**W.E. Dentmon Construction, Inc.**

**ROOMS TO GO – Cutler Bay, FL**

**PREBID REQUEST FOR INFORMATION # 1**

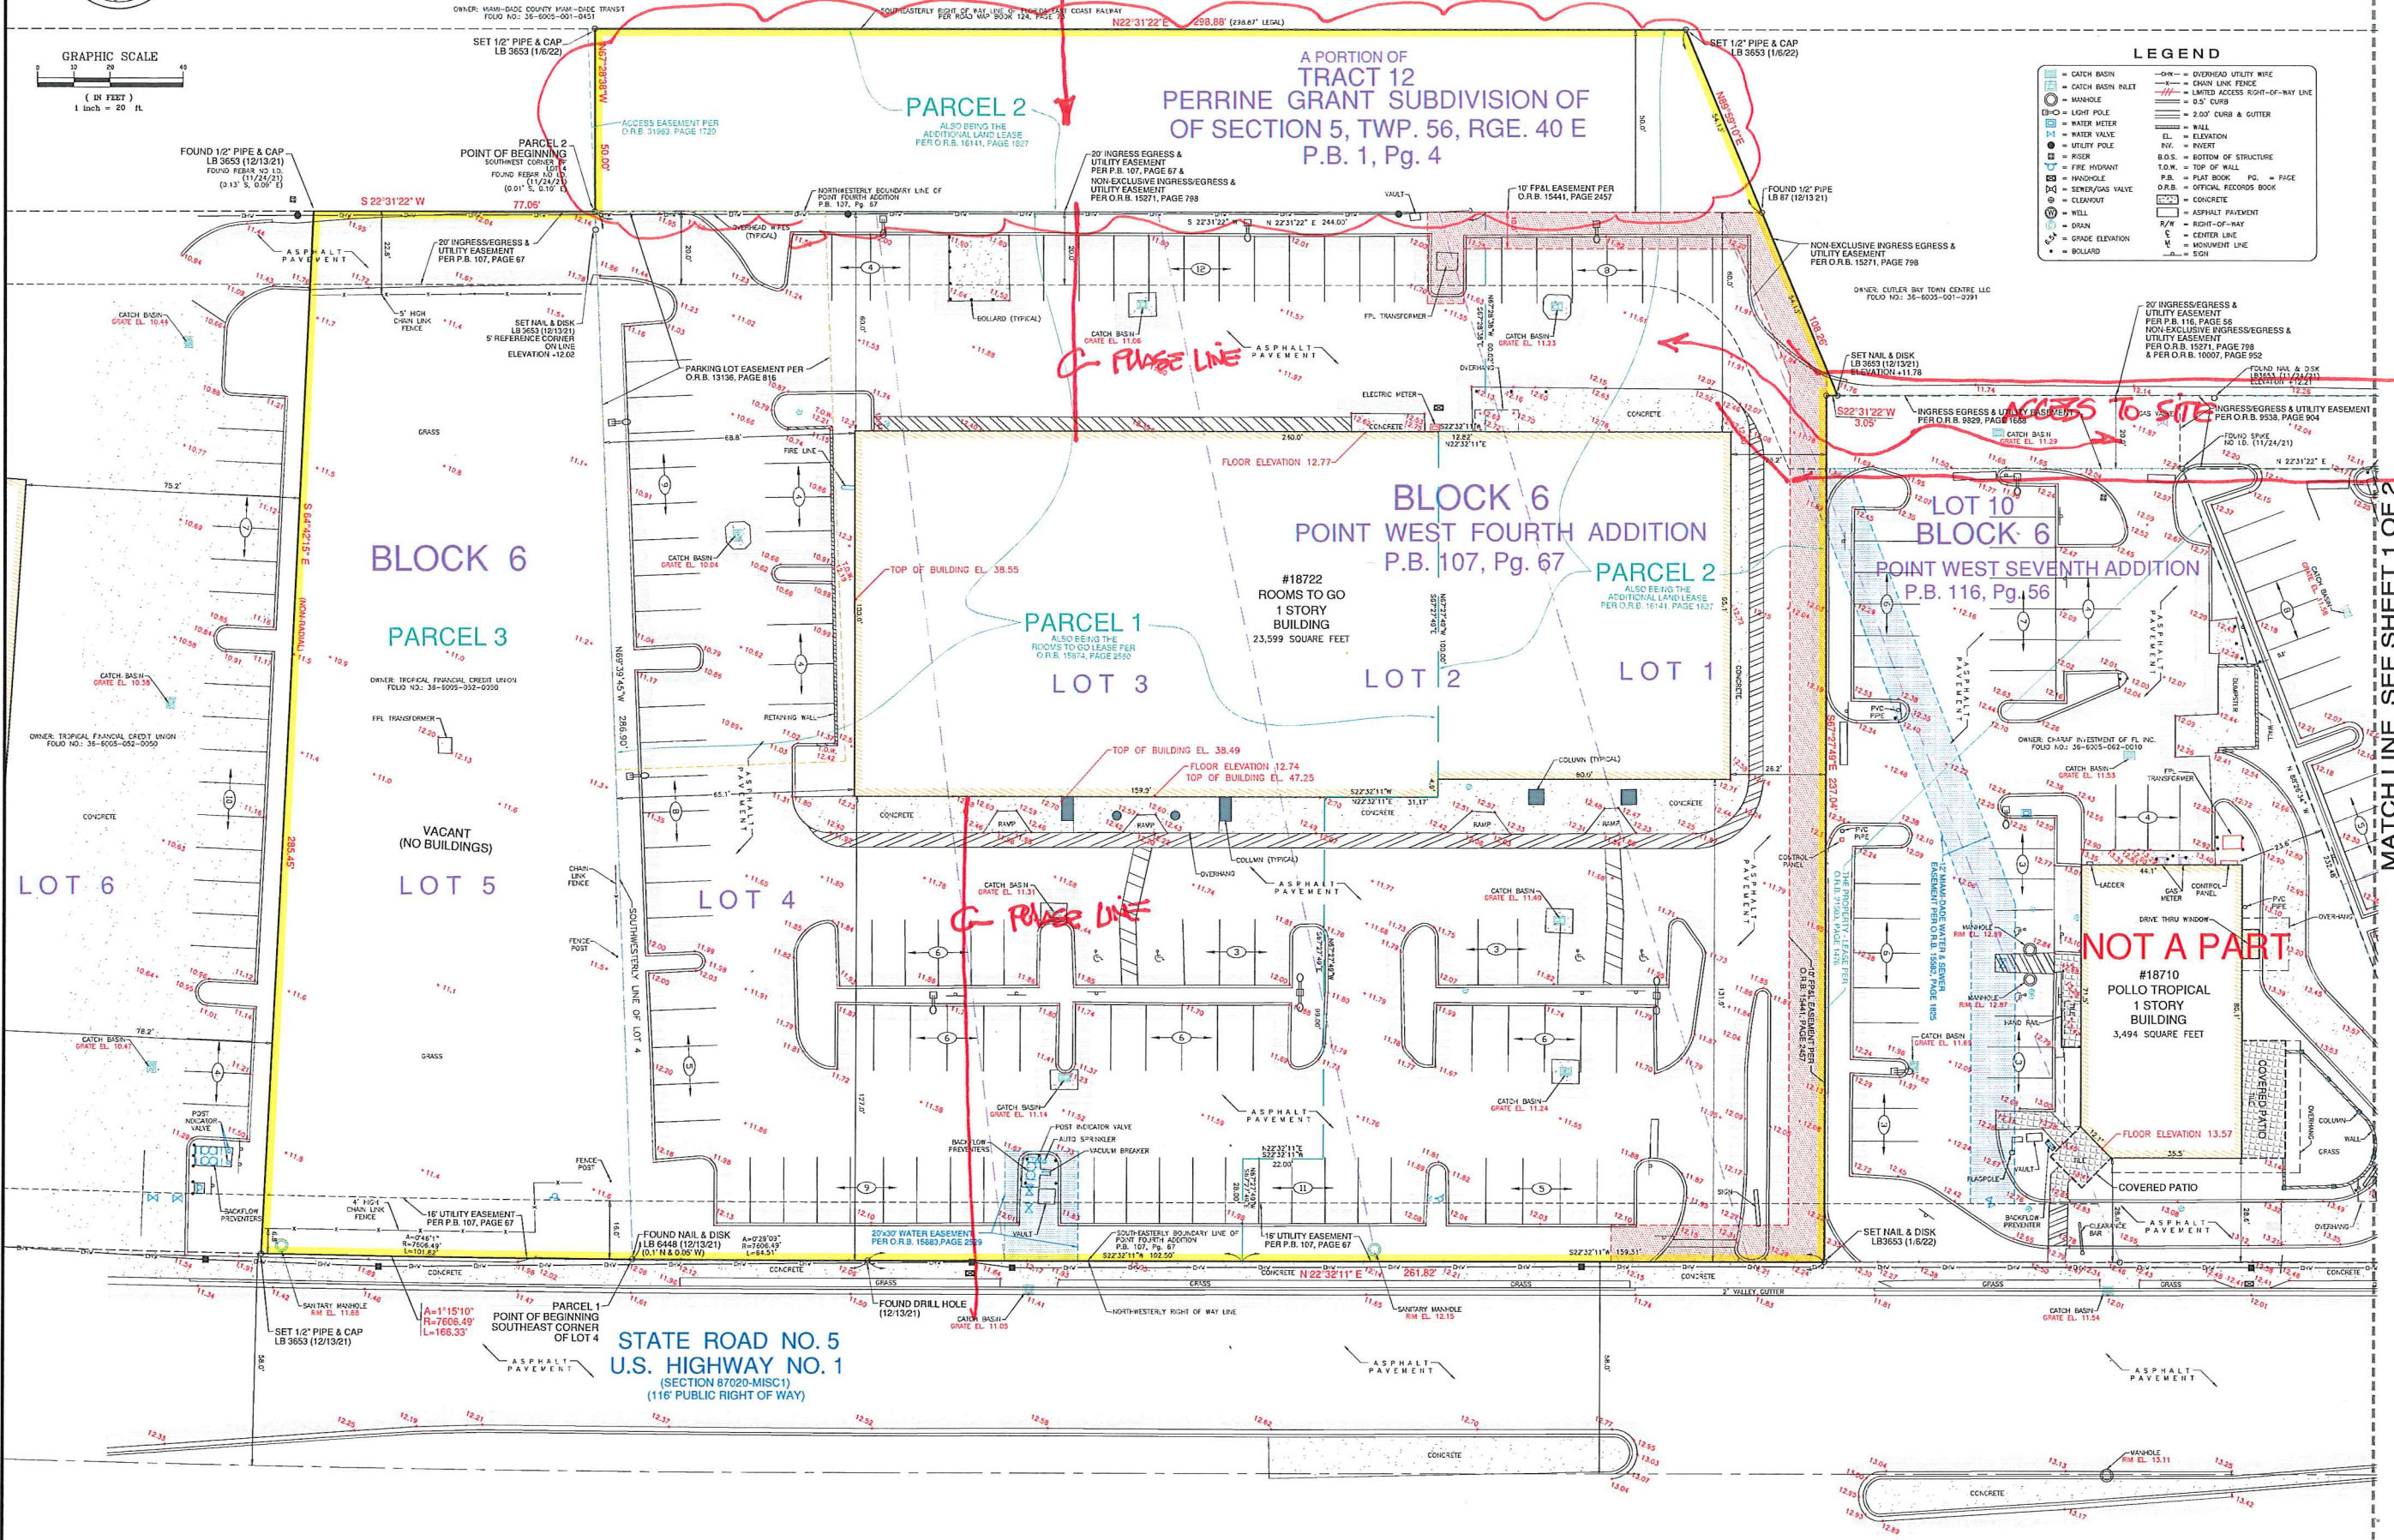
*\* CONFIRM THIS AREA CAN BE USED BY THE CONTRACTOR FOR MTL. & EQUIPMENT STORAGE AS WELL AS PARKING, SINCE OTHER SITE/CIVIL DWGS NOTE THIS AS "NOT A PART" (SEE SD-1, C-016-1.1, C-12-F-3, C-6-1, C-9)*

CAD DATE: 6/8/2023  
SCALE: INDICATED  
DRAWN BY: RL  
LIC:CA7048  
SHEET: **FA-1**

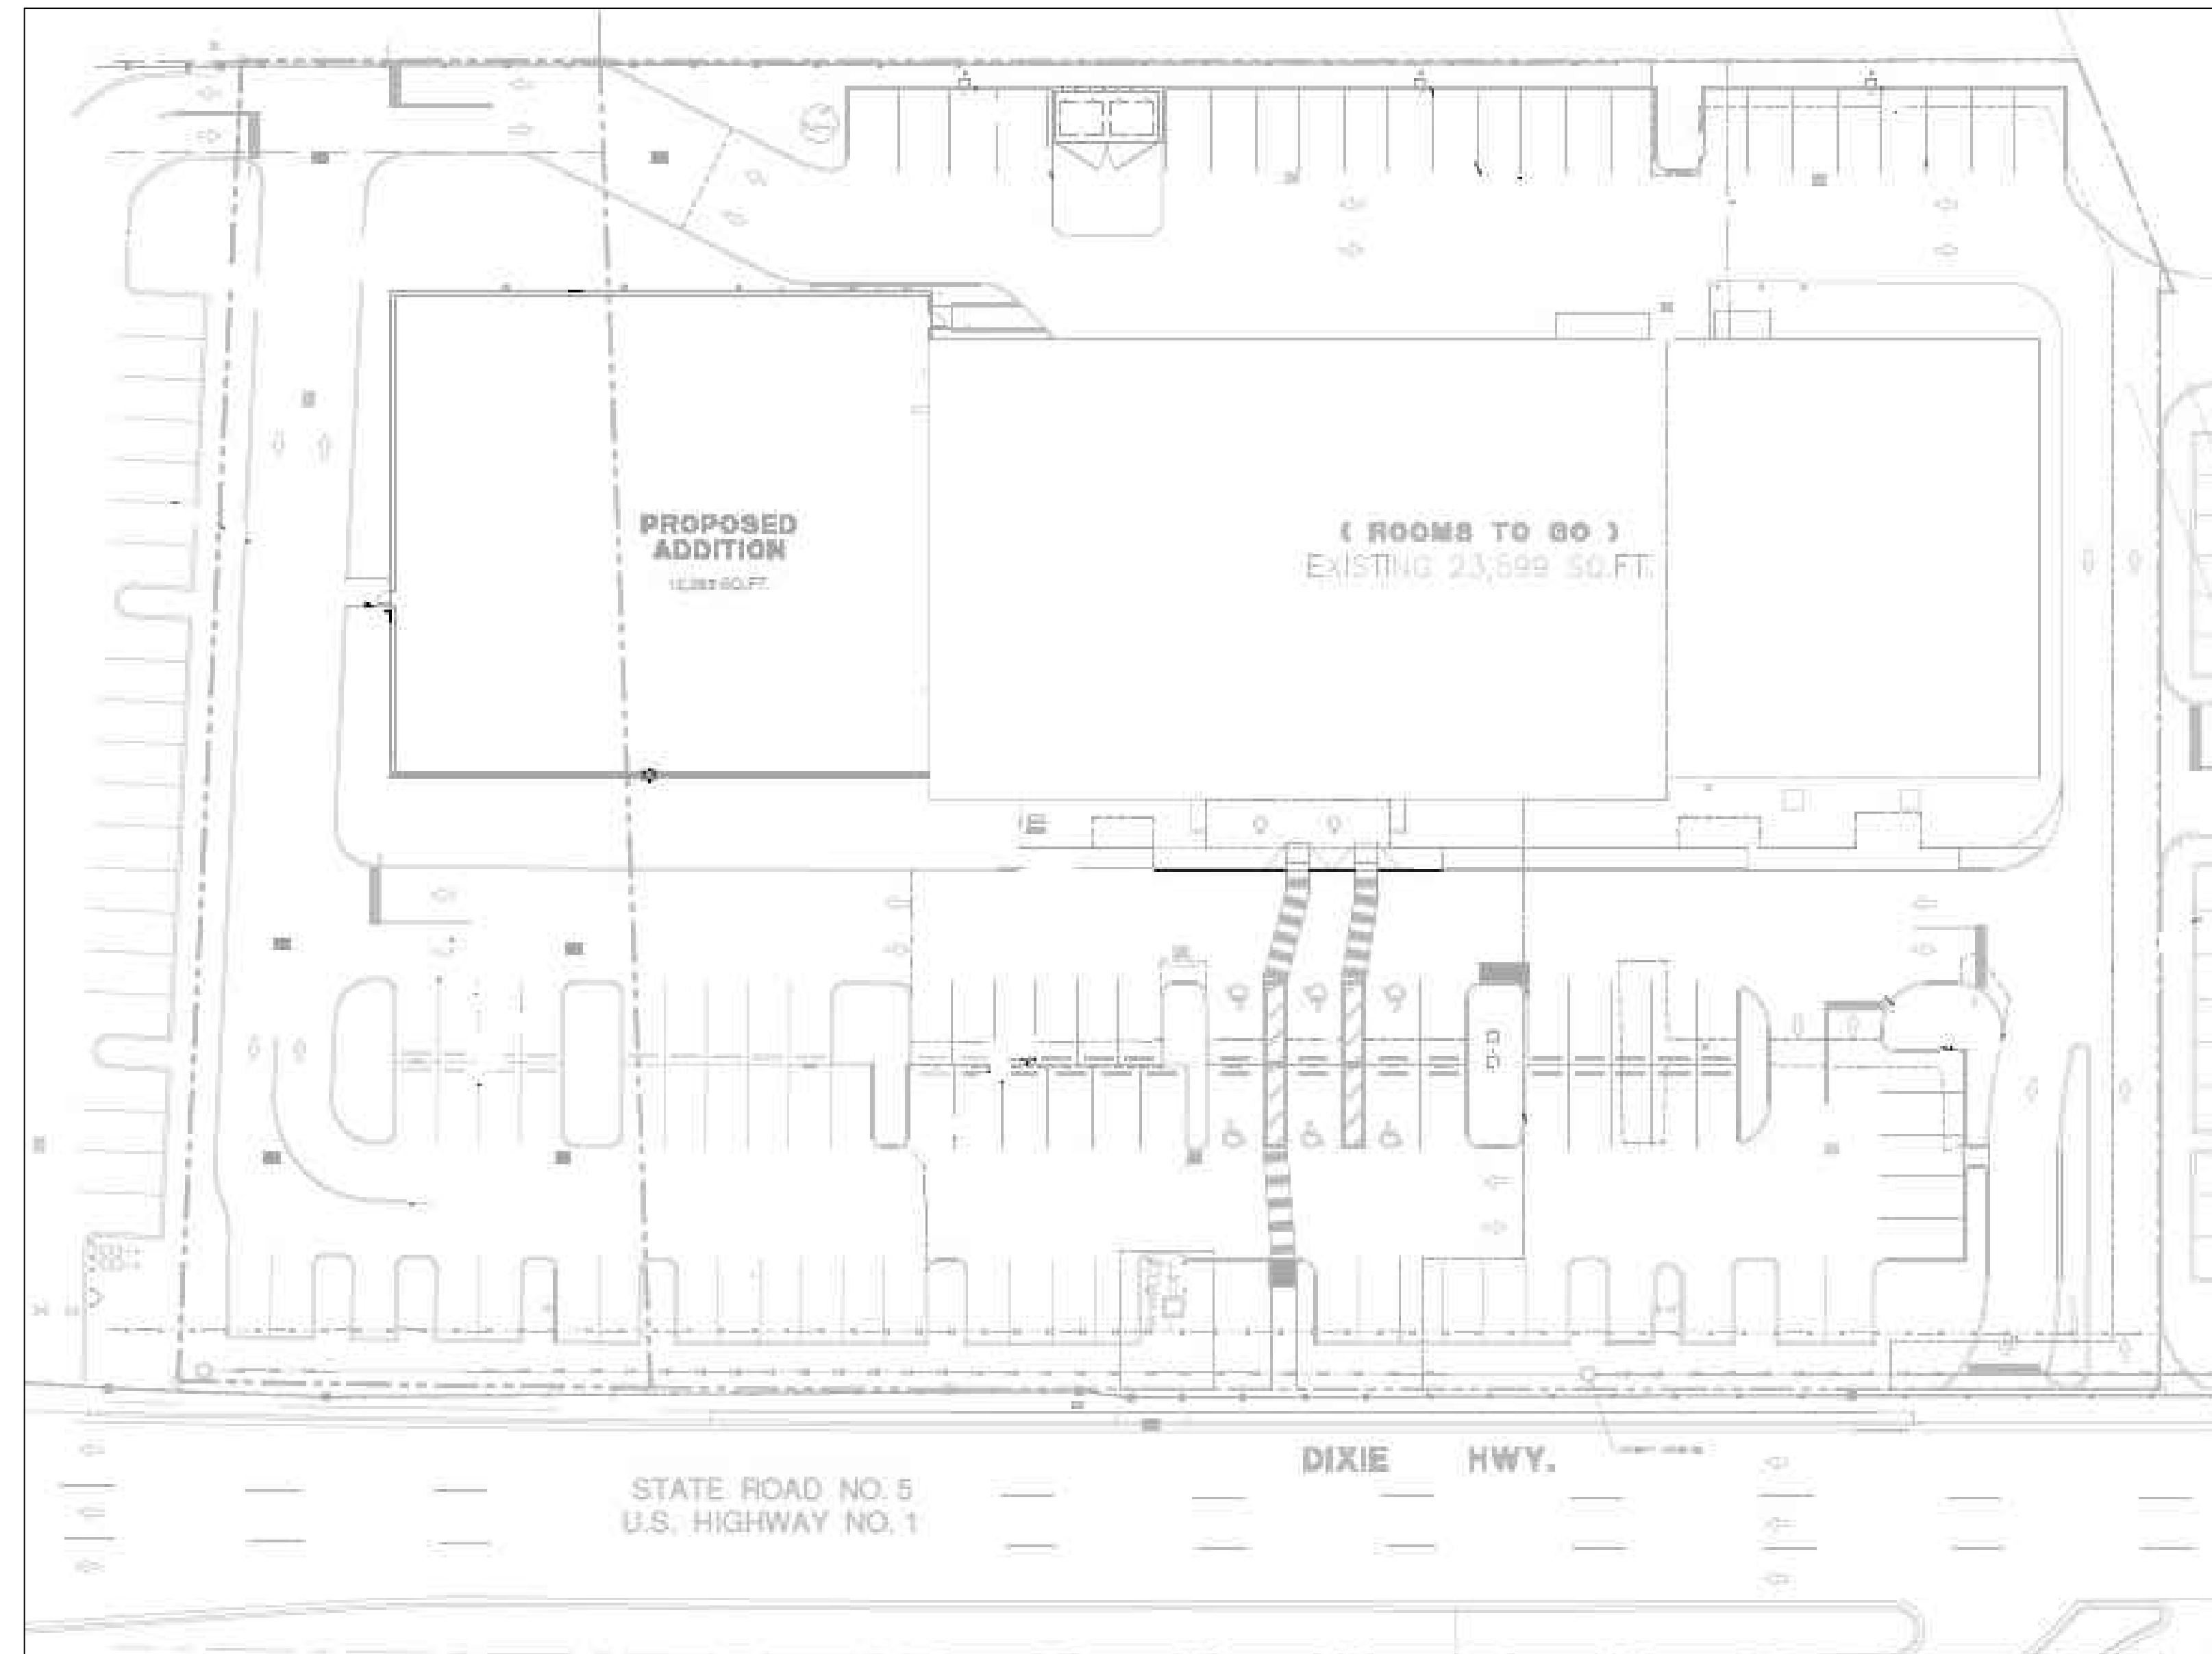
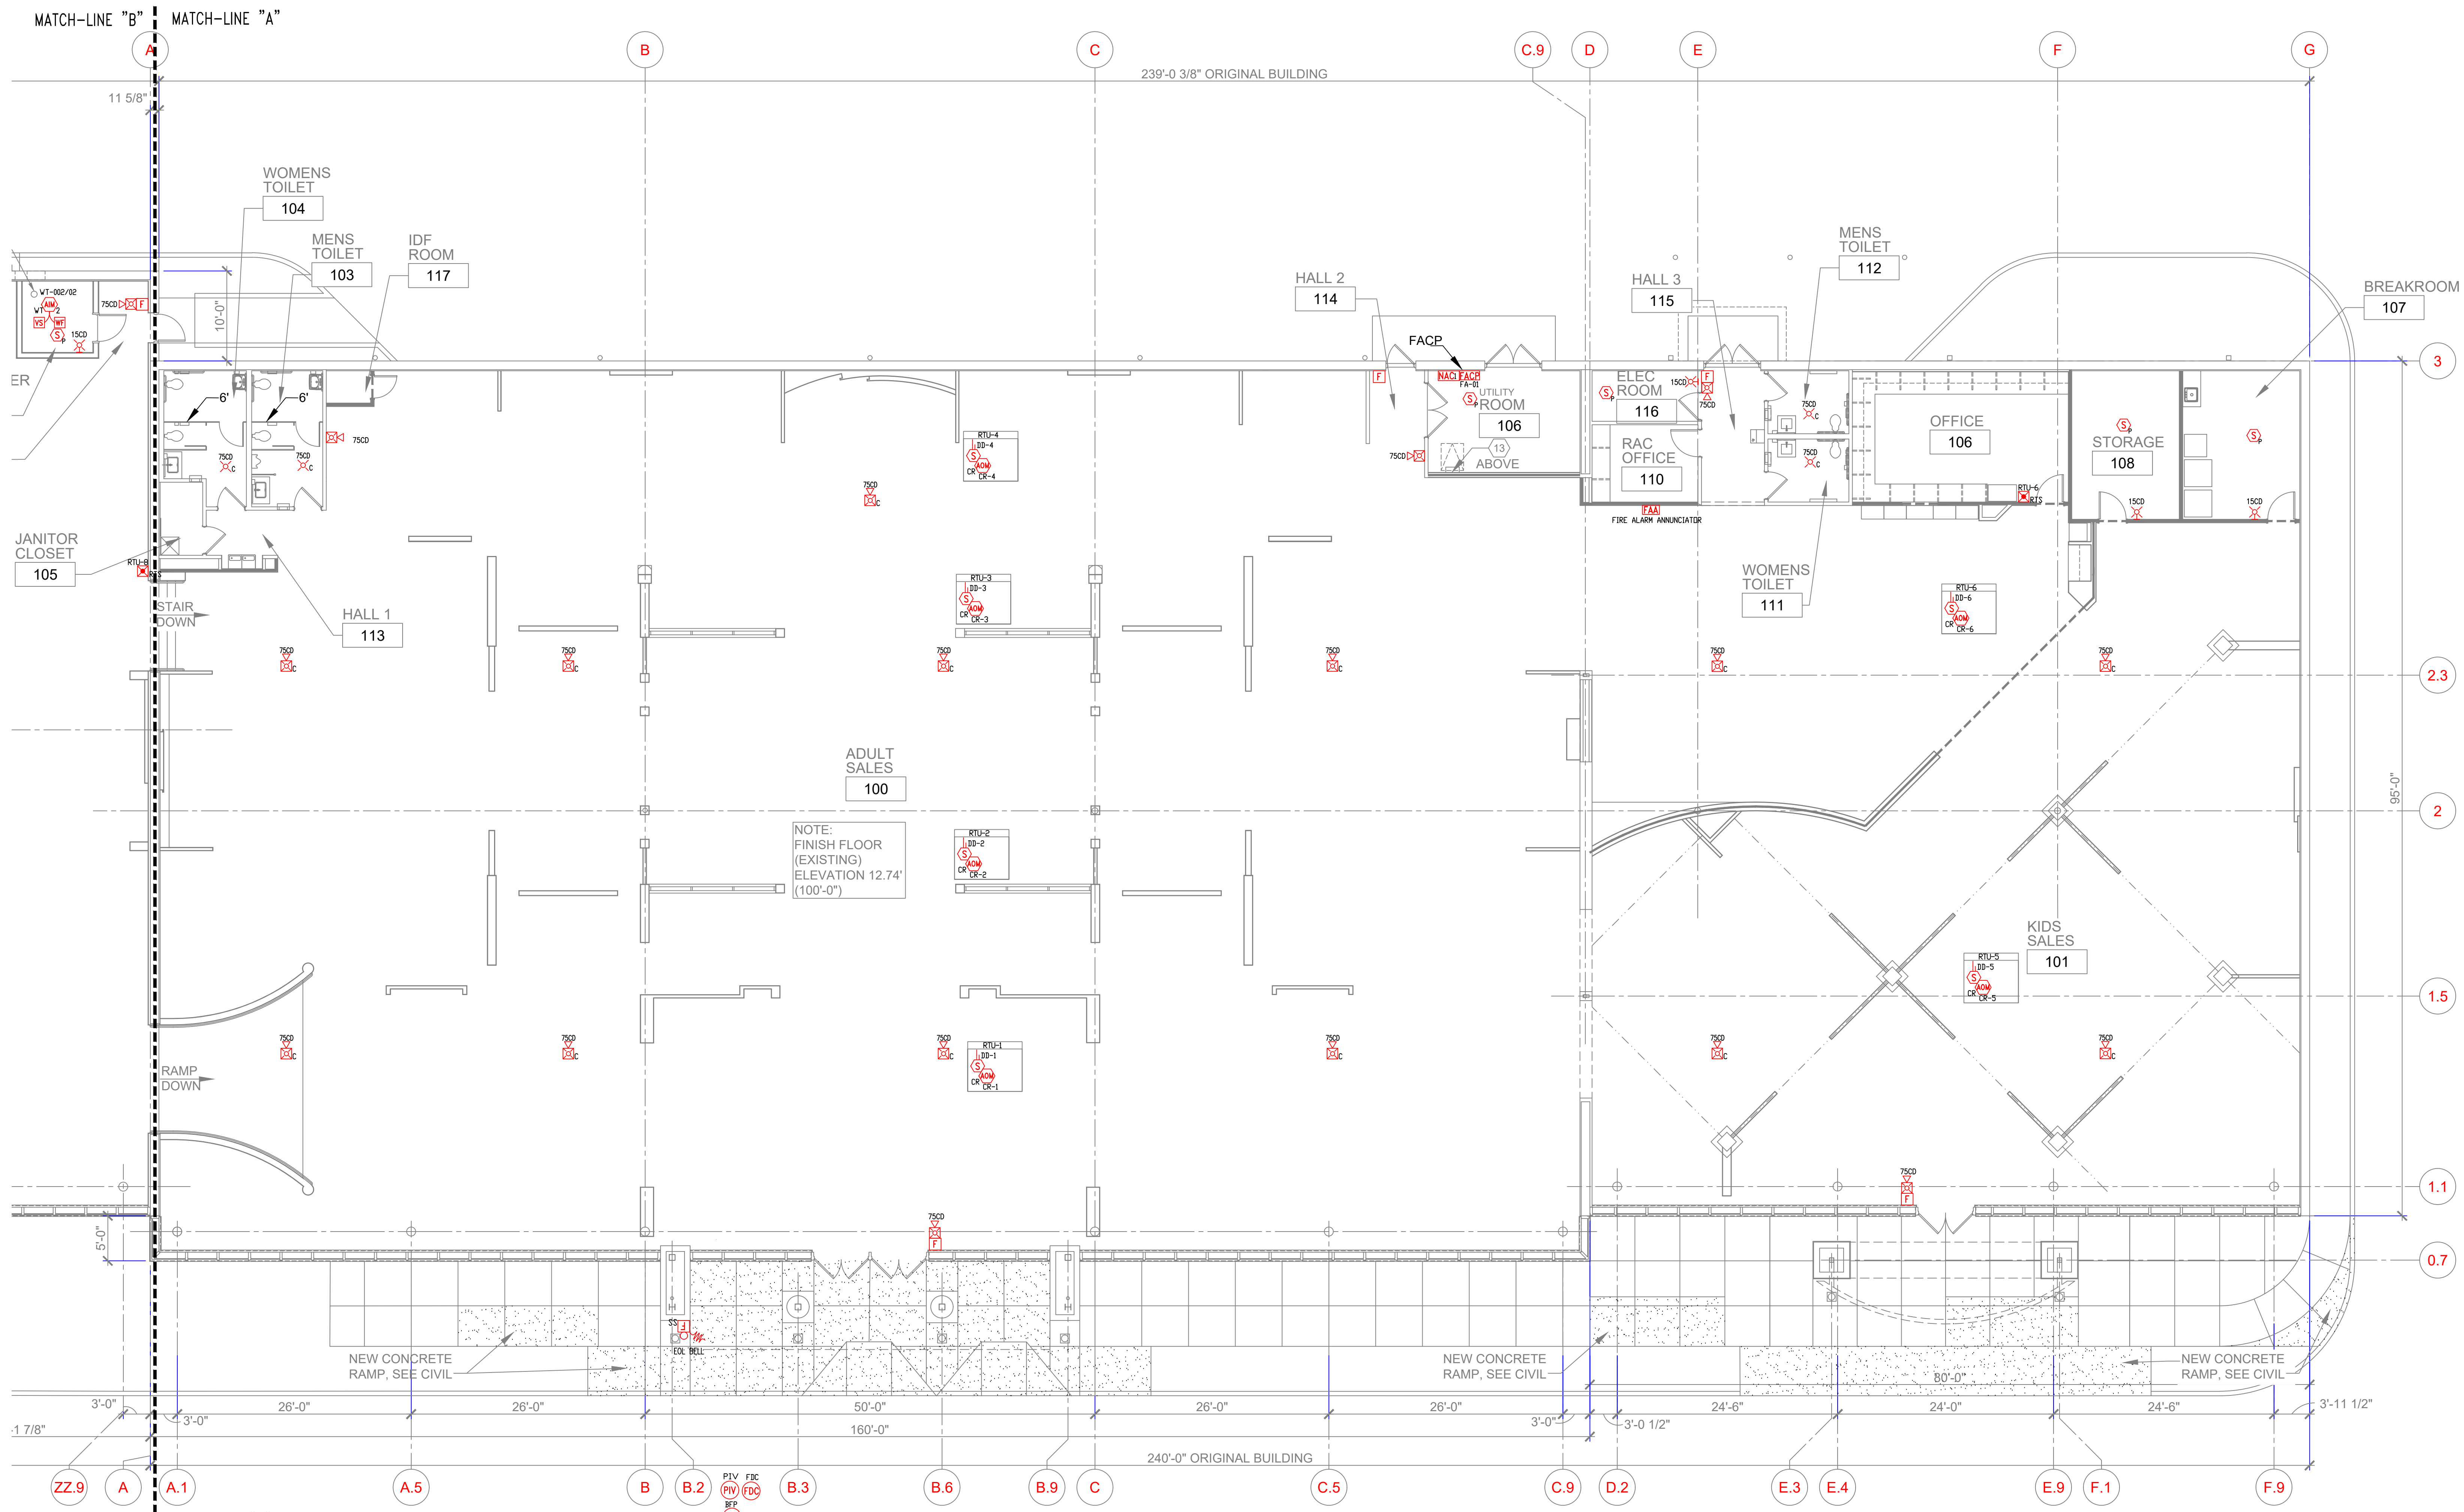
<b>Request Description:</b>
Provide guidance for the replacement of the fire alarm control panel since section 16052 refers to the manufacturer identified on the plans with “no substitutions” and Fire Alarm drawings although neither is included in the bid documents.
<ol style="list-style-type: none"> <li>1. Provide a specification for the fire alarm control panel including manufacturer, model/make, accessories, options, etc.</li> <li>2. Provide fire alarm drawings as stated in Key Note #5 on Sheet E1.1.</li> <li>3. Provide as-builts or shop drawings for the existing fire alarm system(s).</li> </ol>
